February 16, 2023

RE: RZN 22-0004/ORD 2007- Rezoning Glade Spring Crossing, Response and Changes to staff Report received on February 10, 2023

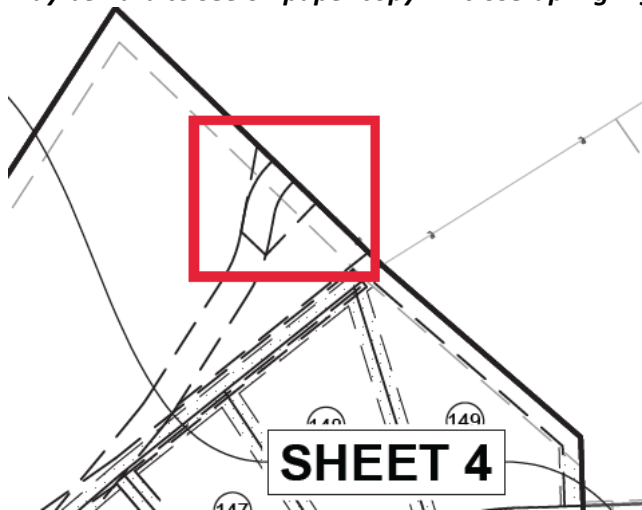
- Response and Changes to Staff Report memo #1(e) indicates that the trail has been realigned and an easement is provided adjacent to the Quinones property.

- o PED exhibit shows original alignment

- o Conceptual Development Plan (DEV sheets) do not show additional easements

Response: They both do show the changed alignment. The trail did not enter the Quinones property at the pond, rather at a location ideal for connection. However, we did add a curve in it to better aid in the transition. The concept plan shows the easement on page 137 but it may be hard to see on paper copy. A close-up highlight is shown below:

SHEET 2 INSERT
 NOT TO SCALE
 KROGER SIDE IS W1; VOLUME II BOOOK STORE IS W9

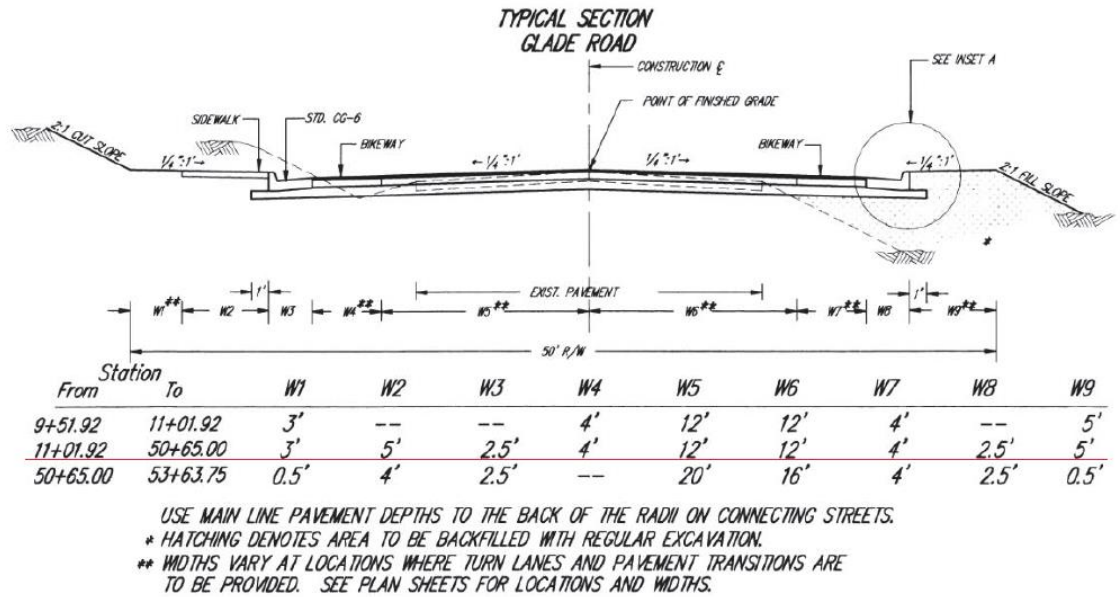
- b. The possibility of re-configuring the existing vehicle travel lanes should be explored.

RESPONSE: E&A has already considered the possibility of re-configuring lanes. Sheet 2 Insert depicts the typical road section at the intersection of Glade Rd & Old Glade Road (STA 48+00). The existing typical section includes the minimum 12' wide lanes for intersections (W5 & W6), 4' bike lanes (W4 & W7). There does not appear to be a scenario in which the lanes can be further reduced to provide a 2' lateral offset for a sign and the size of the stop sign (30"x30") minimum. The evaluation depicts that the bicycle lane at the intersection needs to be converted to a safe haven location for sign clearance.
